P97-133 - Beloit Drive Warehouse Buildings - Lot# 22

- REQUEST: A. **Negative Declaration**
- B. **Mitigation Monitoring Plan**
- C. **Plan Review** to develop two one story warehouse buildings on 7.814+ vacant acres in the Light Industrial (M-1SR) zone.

LOCATION: ⁴⁶⁰¹ 3452 Beloit Drive
APN: 238-0220-022
North Sacramento Community Plan Area
Grant Joint Union School District & Robla Elementary
Council District 2

**Exhibit C-2
SITE PLAN**

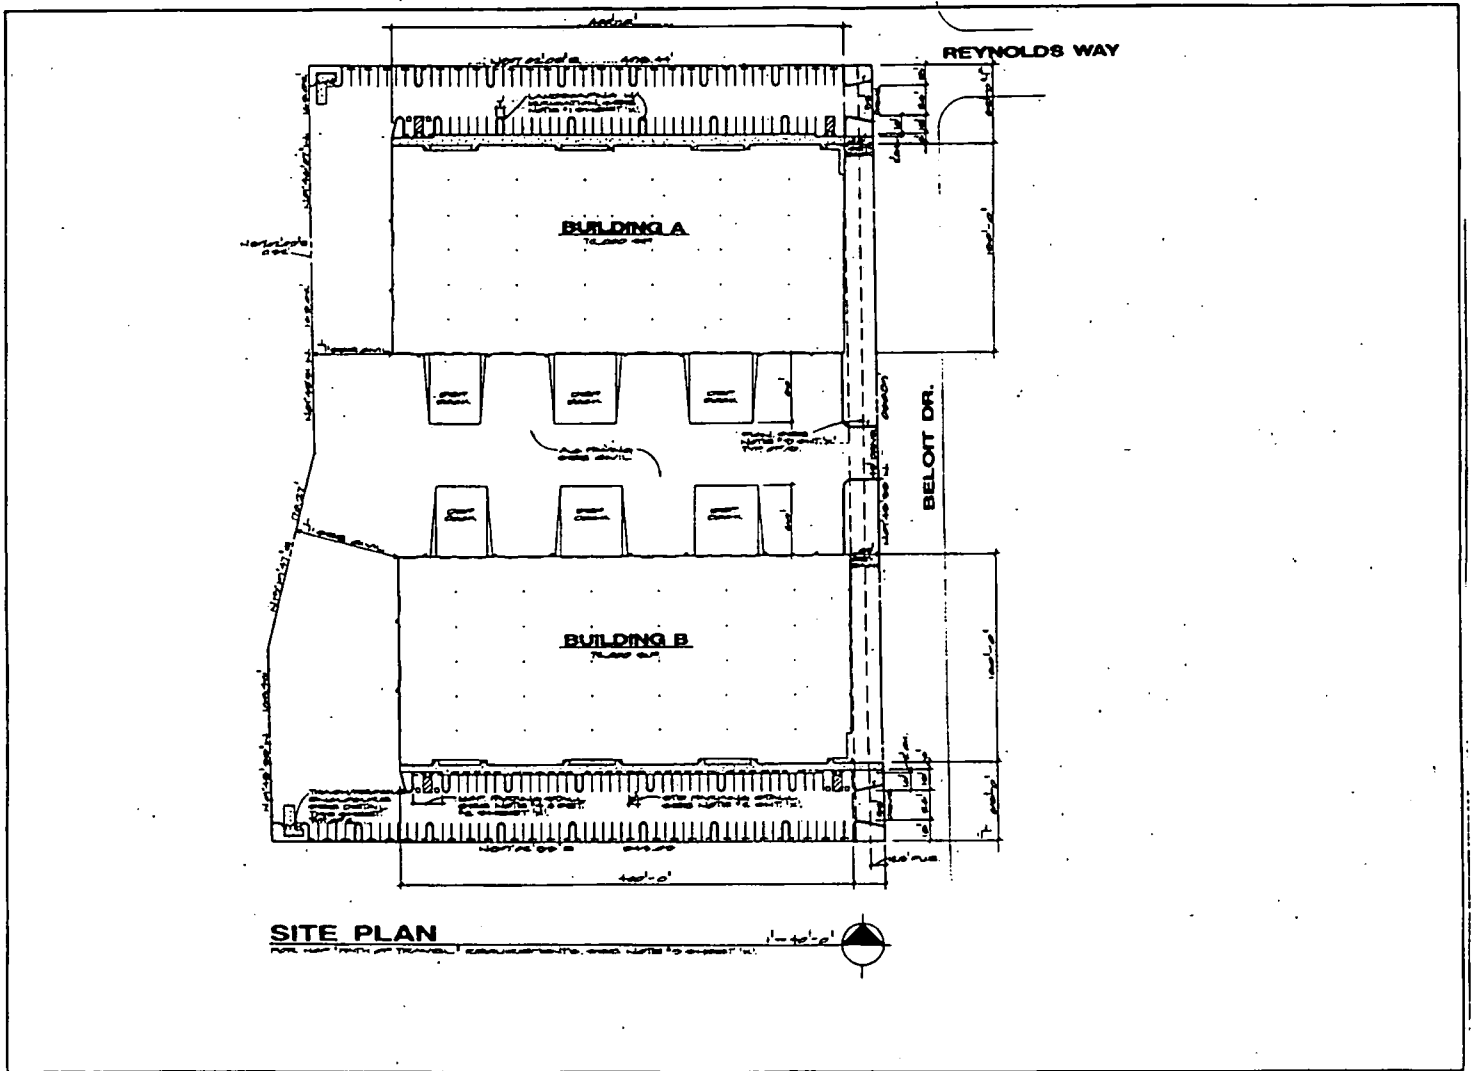
The M-1SR zoning requires a 25 foot building setback along Beloit Drive. Adequate building and landscape setbacks are proposed. The site plan shows the parking areas located north of Building A and south of Building B, respectively.

As proposed on the site plan, both buildings are sited parallel to each other with the loading docks positioned between the two buildings. The buildings' setback along the eastern property line exceeds 25 feet. Along the western property line, Building A is setback 130 feet and Building B is setback 100 feet and 116 feet on the northwestern and southwestern edges respectively. The requirements from Building Division and the Fire Department are summarized below under Summary of Agency Comments.

The submitted plan also indicates two dumpster enclosures located northwest and southwest of property. The trash enclosures must meet all requirements of the zoning ordinance, including perimeter gate, masonry walls, and a solid metal gate. The location of the enclosures do not encroach into the designated parking areas.

The zoning ordinance requires one space for every 1000 square feet of building area for a warehouse use. Based on the proposed 133,200 square feet, a total of 133 parking spaces are required on the site. The site plan indicates 182 parking spaces, eight (8) of which are handicap parking spaces. Staff has no objection to the amount of parking spaces provided.

No bicycle parking spaces are shown on the site plan. The zoning ordinance requires one bicycle parking facility for every 25 off-street parking spaces provided for industrial uses. Staff would recommend that a minimum of seven (7) bicycle parking facilities be provided on site.

Three (3) driveways for ingress and egress into the parking lots and loading docks are located along the east boundary line fronting on Beloit Drive. The northernmost as well as the southernmost driveways are proposed to be 35 feet wide. The driveway into the loading docks is proposed to be 45 feet wide. Public Works Staff has indicated that these driveways shall be to City Standards.

- C1. Comply with the requirements of the Mitigation Monitoring Plan attached in Exhibit C-1.
- C2. Obtain all necessary building permits prior to construction.
- C3. The project site plan shall conform to Exhibit C-2. Maximum square feet for two (2) buildings combined shall be 133,200 sqft. Maximum of 25% of the square footage may be devoted to office usage.
- C4. The trash enclosure must meet all the requirements of the Zoning Ordinance, including perimeter landscaping, masonry walls, and a solid metal gate.

-
- C5. At least, seven (7) bicycle parking facilities shall be provided on site.
- C6. Fifty percent shading shall be provided for the designated parking, maneuvering and driveway areas depicted on the site plan.

**Exhibit C-3
ELEVATIONS - BLDG. A**

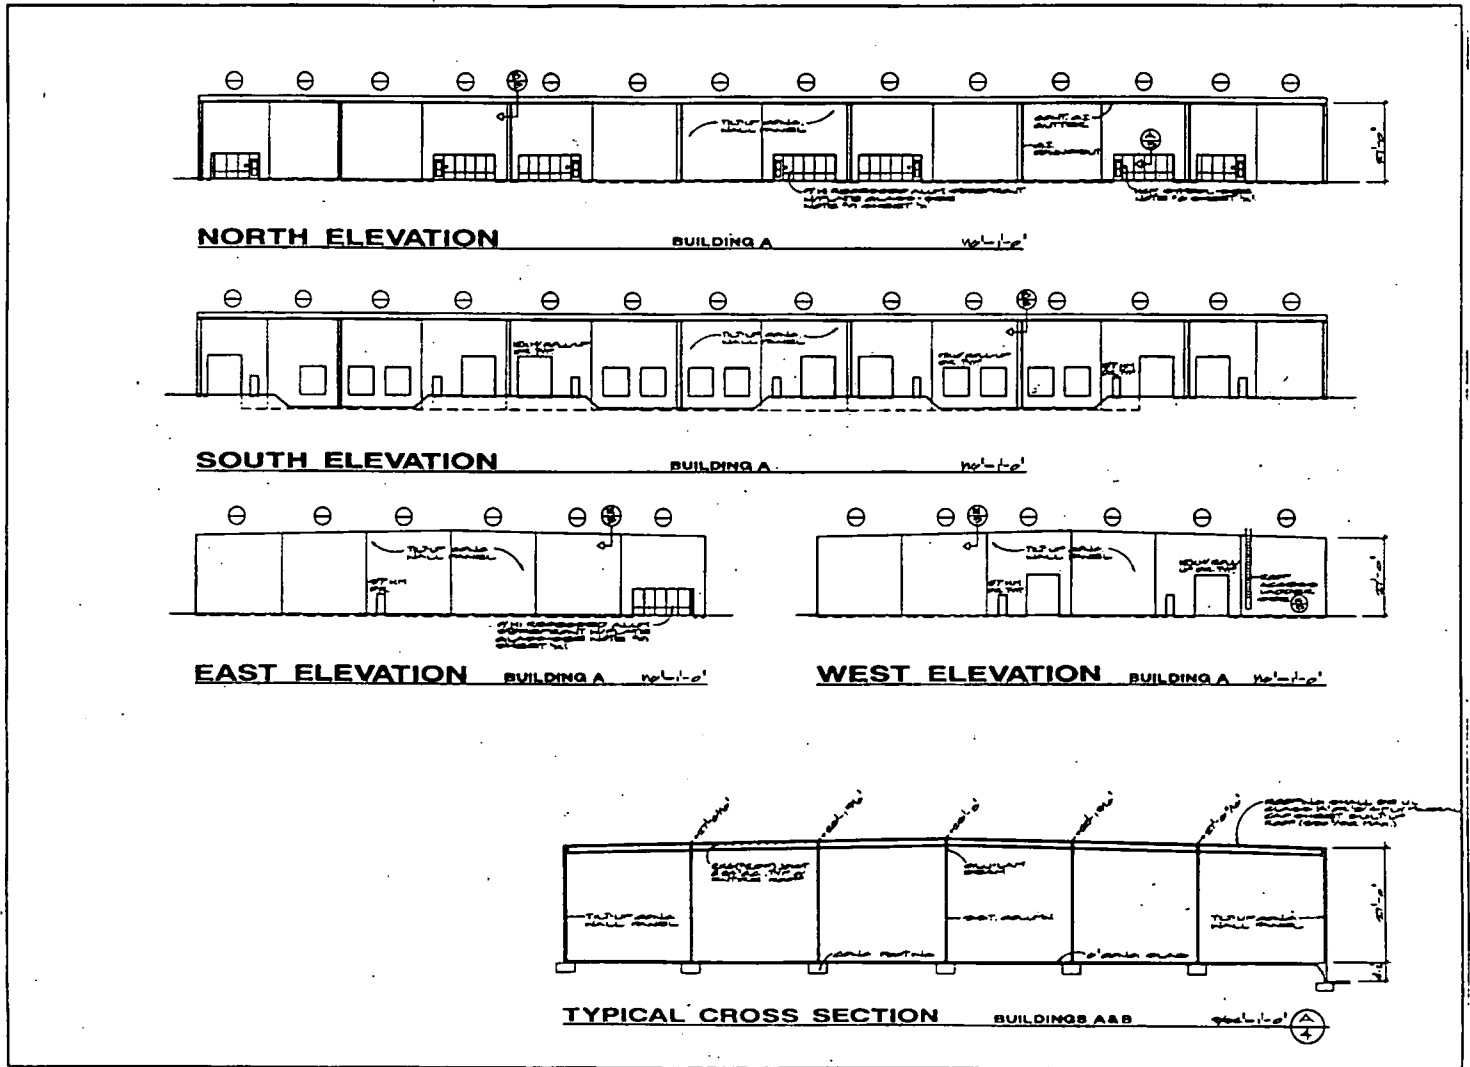
The applicant proposes to construct two 29' high speculative warehouse buildings totaling 133,200sqft. (Bldg. A: 61,200sqft.; Bldg. B: 72,000 sqft.). Concrete block is proposed for building material with hot mop, built-up roof. The exterior building colors are not yet determined. Staff will recommend that the colors used shall conform with the existing colors in the industrial area. These colors shall be reviewed by Staff prior to building permit issuance.

It is recommended that all mechanical equipment be placed behind the parapet wall to not be visible from Beloit Avenue. Staff finds the building design compatible with the surrounding area and will enhance the area.

- C11. The edges of the elevation facing Beloit Drive shall be accentuated with flush pilaster features created by using 2-3 inches wide reveal lines and painted with a contrasting color consistent with applicant's corporate colors. This feature shall continue to the northern and southern elevations of Buildings A and B respectively. A multi-color paint scheme highlights the lines and the store front area, if provided, and makes them a prominent design feature. This shall be subject to review and approval by Staff.
